PLANT NAME: Duane Arnold Plant

IOWA ELECTRIC LIGHT AND POWER COMPANY

Transmitted herewith, in accordance with the requirements of 10CFR50.59 and 50.90, is an application for amendment of DPR-49 to incorporate proposed changes in the Technical Specifications (Appendices A and B to License) for the Duane Arnold Energy Center (DAEC), described in the enclosures hereto.

PROPOSED CHANGE ETS-16 TO DAEC TECHNICAL SPECIFICATIONS

FIGURE 4.3-1 RADIOLOGICAL ENVIRONMENTAL MONITORING PROGRAM SAMPLING STATION

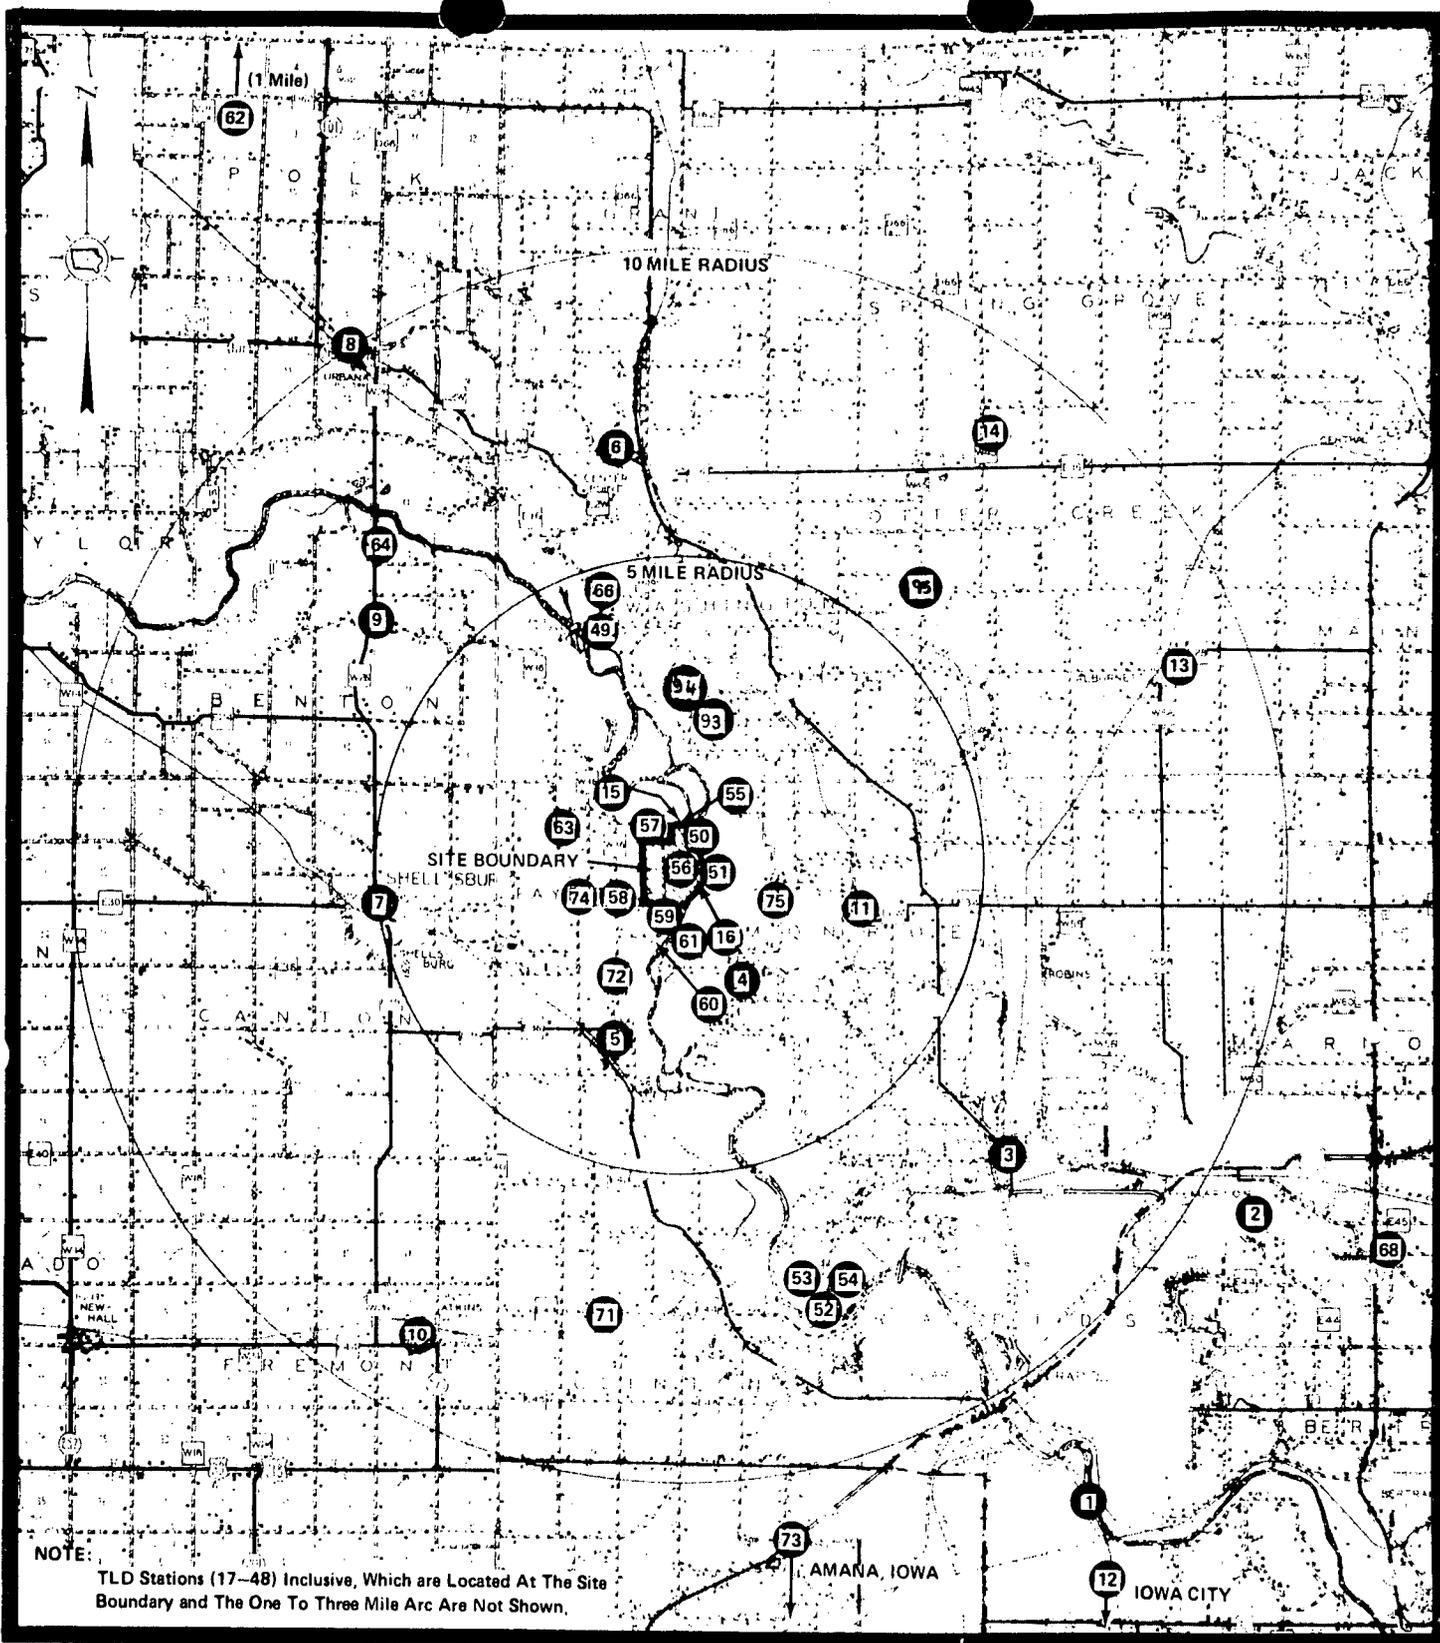
The above changes were also made on Figure 4.3-1, "Radiological Environmental Monitoring Program Sampling Stations". In addition, Sampling Point 70 was deleted from Figure 4.3-1.

This deletion (Sampling Point 70) had been previously approved by the NRC for Table 4.3-1 (Amendment No. 7, Change 8 to Operating License No. DPR-49, dated May 16, 1975), but was inadvertently not deleted from the figure at that time.

Delete Sample Points "67" and "68" and add Sample Point "95".
